Angio to Cath. Lab Renovation

ADDENDUM #2

TCMC Angio to Cath Lab

BID ADDENDUM NO. 2

PROJECT TITLE:
TCMC ANGIO TO CATH LAB
RENOVATION
PROJECT #: 01608.00
DRAWN BY: JK
CHECKED BY: YB
SCALE: AS NOTED
DATE: 10/10/16
SHEET NUMBER:
M201

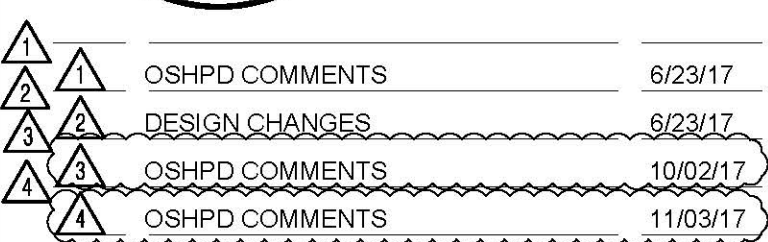
General Contractor shall allow for a two men two days field investigation to perform work as noted in notes 7 and 8 on attached sheet M-201. Provide proposed cost as follows:

7 Exact location of damper shall be verified/determined by the contractor.

8 Contractor to determine suitable location for damper outside of the corridor.

SHEET NUMBER: M202

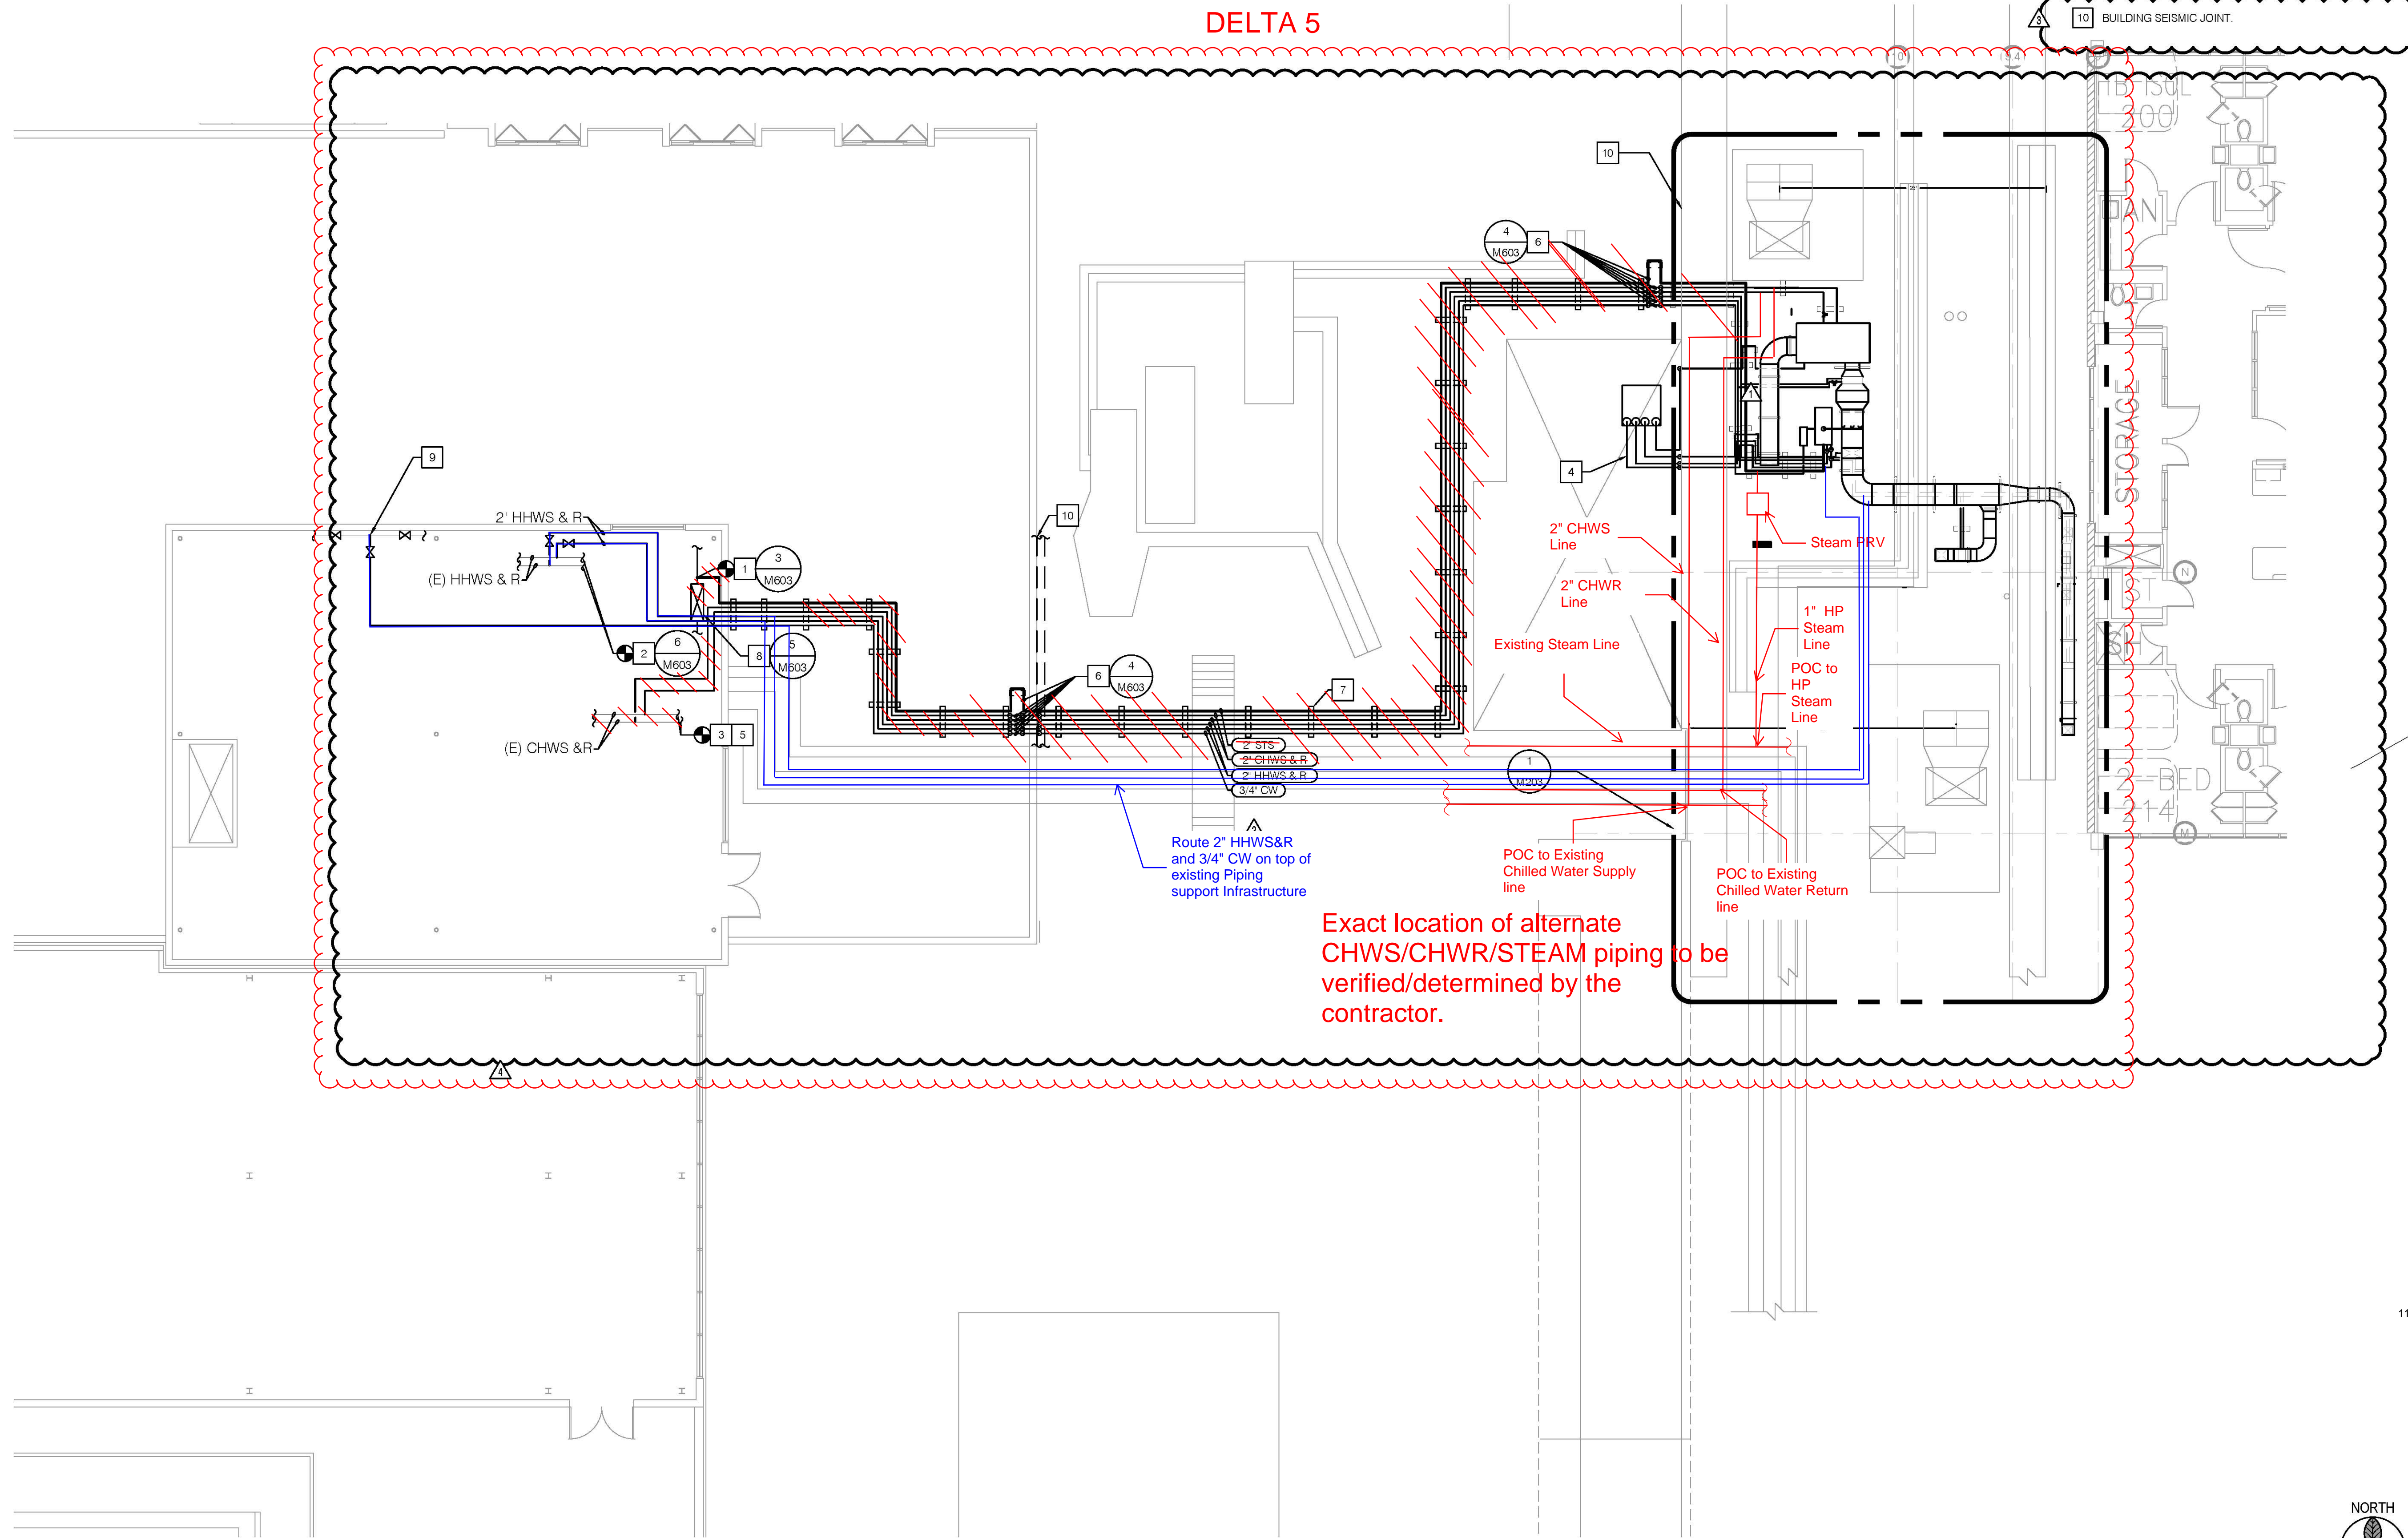
- Item No. 2 - ALRTERNATE 002 – DEDUCTIVE COST:
General Contractor shall provide a deductive cost alternate to provide the revised scope shown on attached sheet M202 clouded in delta 5.
Add and delete duct supports, roof patches and stair modifications as needed to reflect the revised scope.

RFI:001

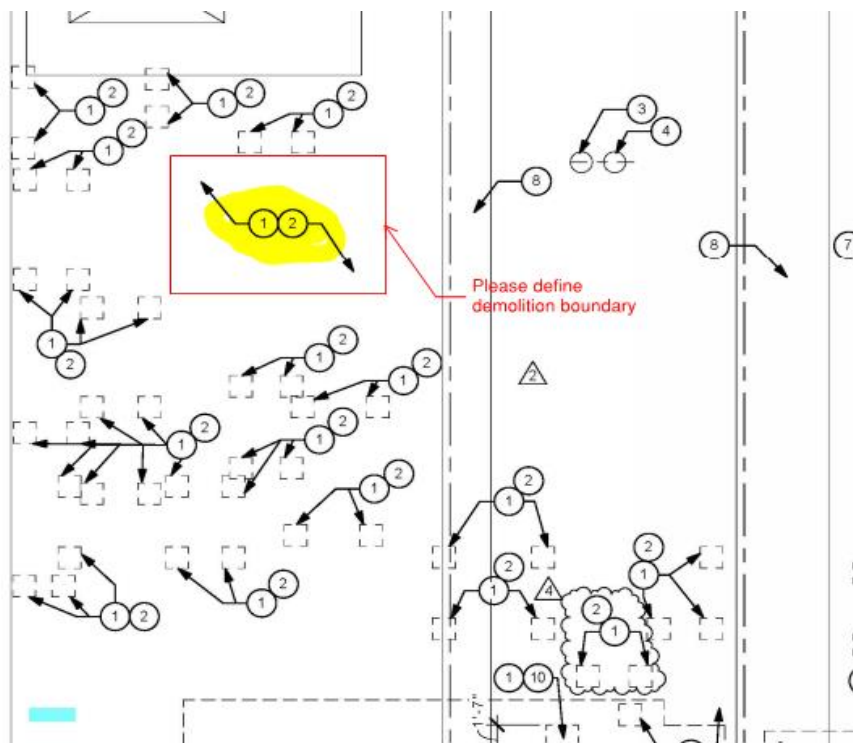
- **SITE VISIT CLARIFICATION: December 12, 2017**
 1. Drawing A4-01, Demolition Notes 1 and 2, removal of roofing, Insulation and Aggregate, what extend is the demolition work. (See attached Highlighted Drawing for Reference). Please define the extend of demolition.

Response to 1. - Refer to Roof Plan 1/A4-11 and Detail 3/A4-11. Overlap of new roofing membrane over existing shall be 12" min.

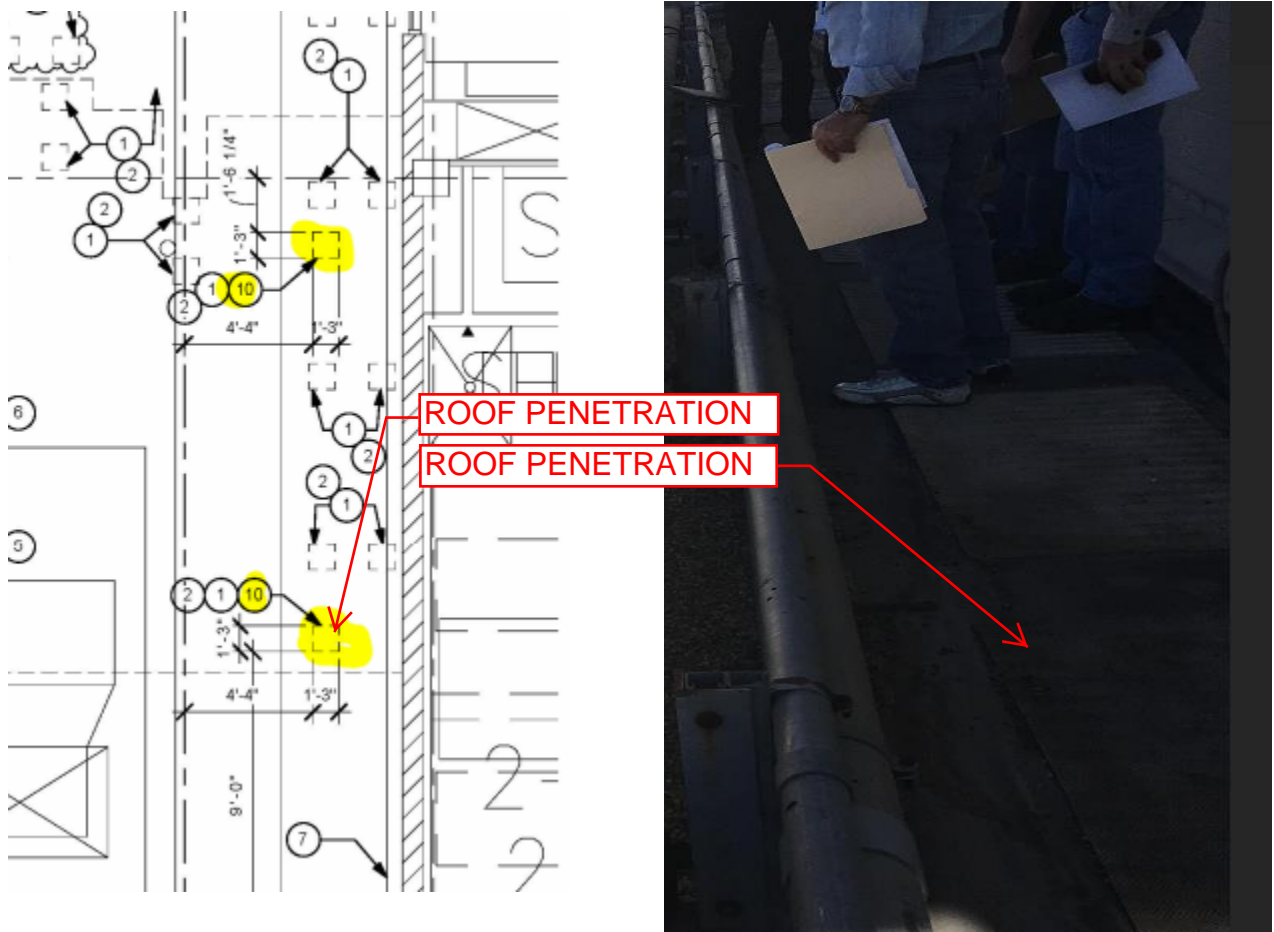
2. Drawing A4-01, Demolition Notes 10 sawcut existing concrete roof deck for new ductwork and duct insulation, per site visit this penetration is on the walkway area. Are there any conflict underneath example beams, columns etc. Please confirm that this are the right location. See Refence Drawing and Photo.

Response to 2. - Proceed as per contract documents.
